PZ&B Staff Combination Memorandum: Town Council and Landmarks Preservation Commission

SUBJECT: ZON-24-003 (COA-23-047) 340 ROYAL POINCIANA WAY (COMBO)

MEETING: DECEMBER 13, 2023 TC
DECEMBER 20, 2023 LPC

RESTAURANT

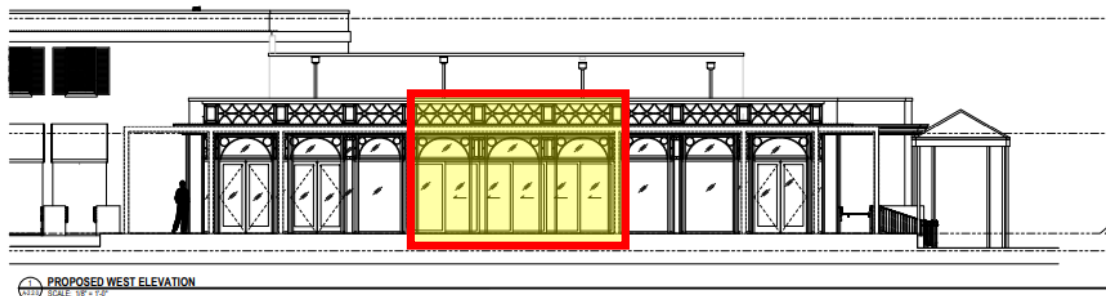
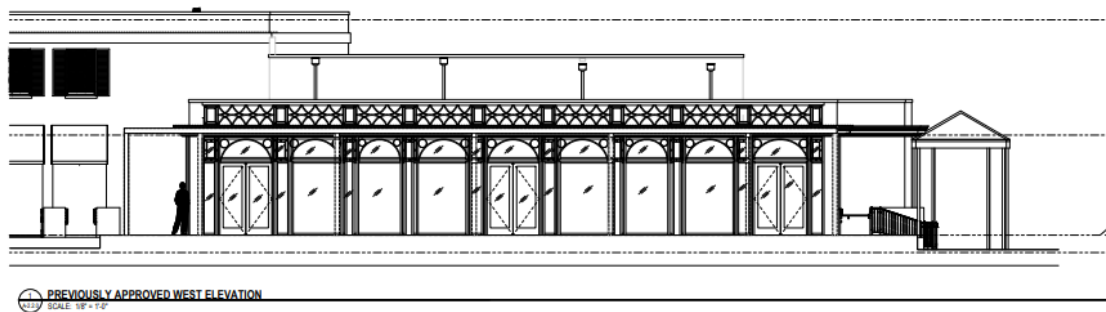
There are some exterior façade alterations to the south and west façades from previously approved COA. Primarily due to the extent of the modifications previously approved, staff has no outstanding issues with the proposal; although the Towns' Preservation consultants do raise concerns pertaining to the proposed introduction of sliding doors along the west elevation.

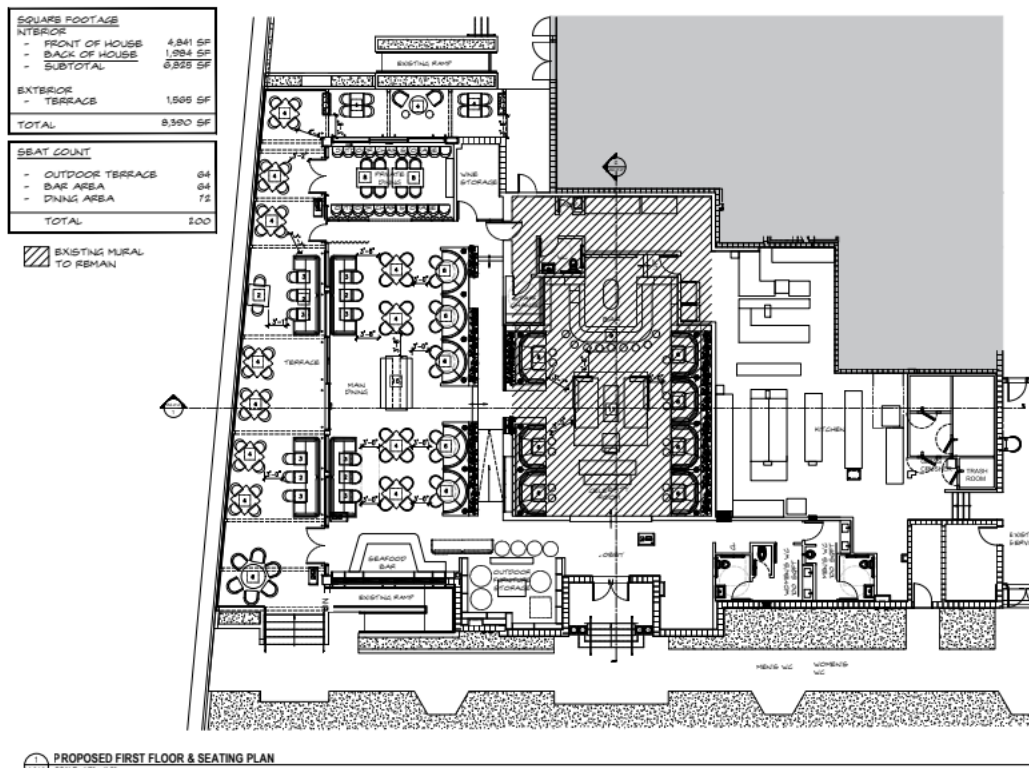
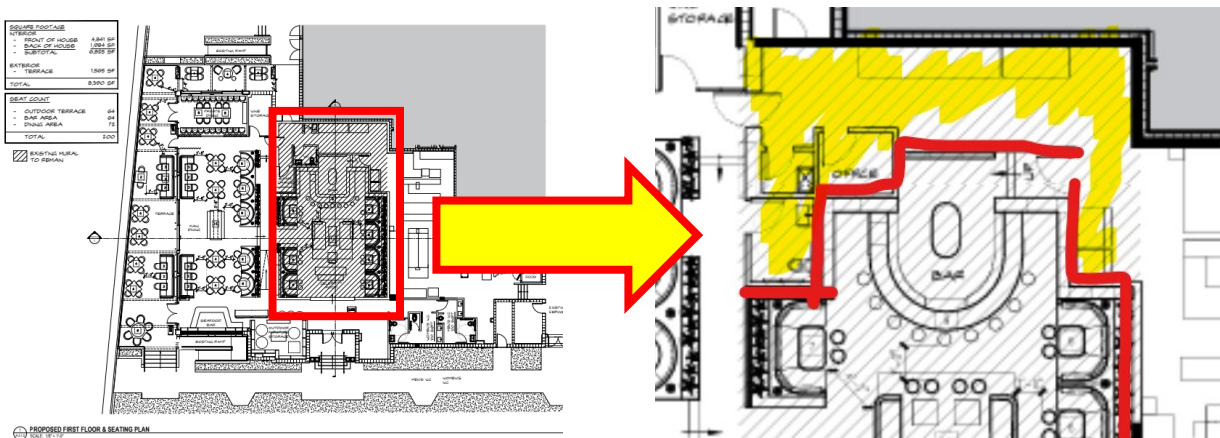
Staff does have some concerns with the interior layout of the restaurant and the incorporation of the retained mural. Sheet A-2.1.0 depicts the ceiling area of the mural, but no reflected ceiling plan has been provided as requested by staff, as it appears interior layout of space, ie back of house operations, will “interrupt” the mural. Staff has requested design details of this interior configure but has not received any additional materials or design details or resolutions

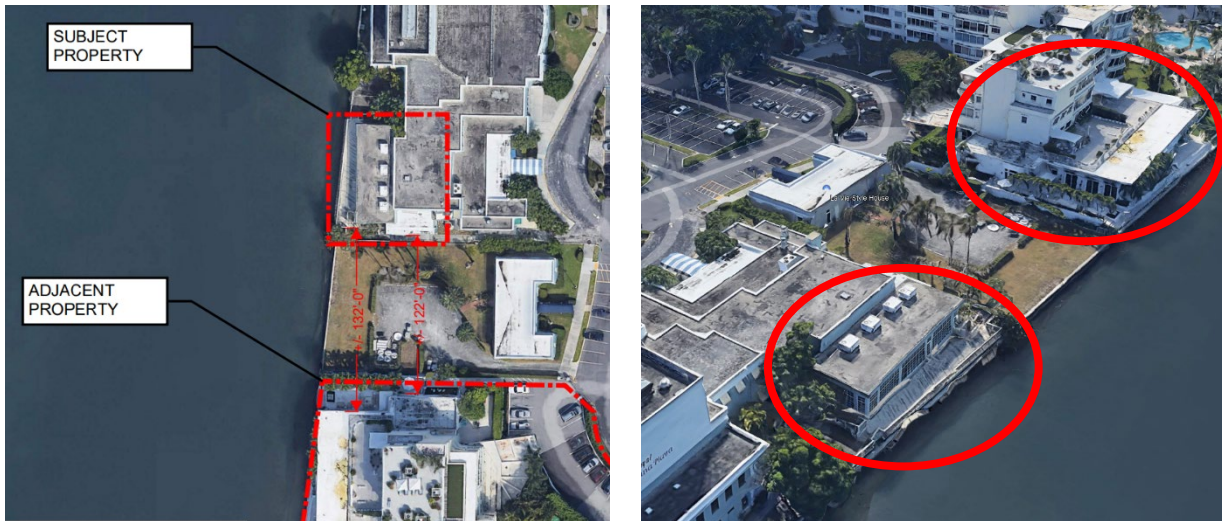
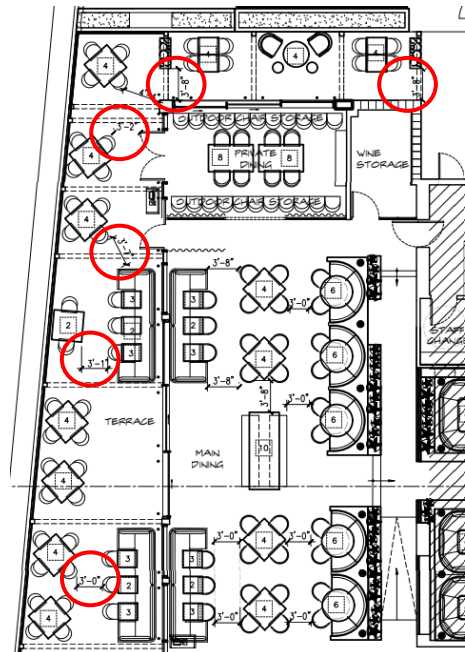
The neighboring residential seven-story Condominiums building to the south, Palm Beach Towers, is located approximately 132'-0" from the waterfront terrace. Although the tower does not have many exterior balconies positioned along the north side of the building that are proximate to and face the Plaza, there is one expansive terrace for a single unit at the second level (shown below).

It remains to be seen what, if any, will be the audible impacts of a 64-seat **outdoor** dining component with an indoor restaurant that has operable sliding doors will have given the waterfront nature. It is commonly understood that water refracts sound and therefore sound travels further over water: less is lost up into the air. Given the adjacency of a 270 condo unit building, a sound study should be submitted by the applicant, demonstrating what impacts a 64 seat outdoor dining component will have. During the submittal process staff had requested a sound study, but has yet to receive one. At this time, it may for Town Council to consider limiting the # of seat by 50% for a full season to assess any potential impacts. Additionally, such decrease in the amount of seating will provide the room for the seating plan to comply with Sec. 134-2106 (b)(1)(4) which requires a minimum four foot-wide unobstructed pedestrian path is maintained at all times; sheet A-2.1.0 still shows conflict with this regulation in at least six (6) instances (and more are evident) which may be an indication of overpacking the 1,565 SF terrace area with seats.

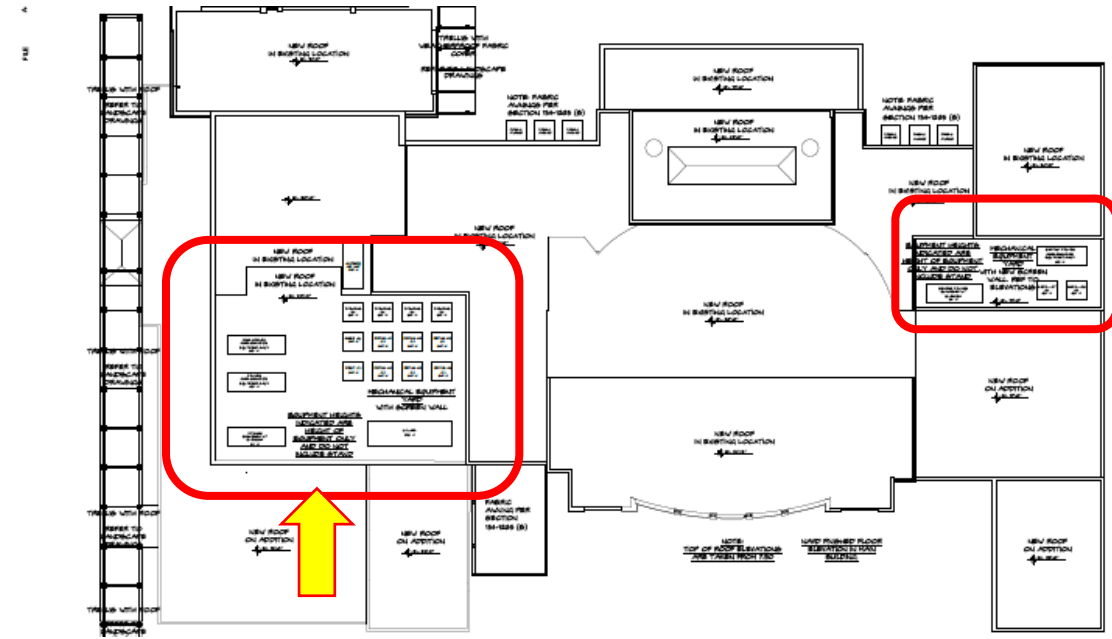
The 2022 application received an approval for a variance (Variance # 3) from Sec. 134-1607(1), to permit 16 air conditioning equipment units on the roof at the maximum height of 108" in lieu of the 48" maximum. As part of this application, the design features a new kitchen scrubber in the approximate location of the AC units that also exceeds the height limitation for mechanical

projections. The Town's zoning code distinguishes what types of equipment are permitted for what height allowances. This application seeks a height variance from 36" in order to permit a 84" high kitchen scrubber on the roof.

There are two rooftop areas that received approval for equipment height variance—the north and the south side. The request as part of this application pertains to adding an additional kitchen scrubber to the south side. Staff has no objections to the request as it is the logical placement of such equipment, located above the interior buildout of the kitchen and located within the allocated “rooftop equipment yard” provided that there is screening methods adequately mitigate any negative visual impact when viewing the building. The incorporation of a rooftop scrubber greatly aids in the control of common kitchen exhausts that contains grease, smoke, and odors and assist in filtering these properly to help meet air quality standards.
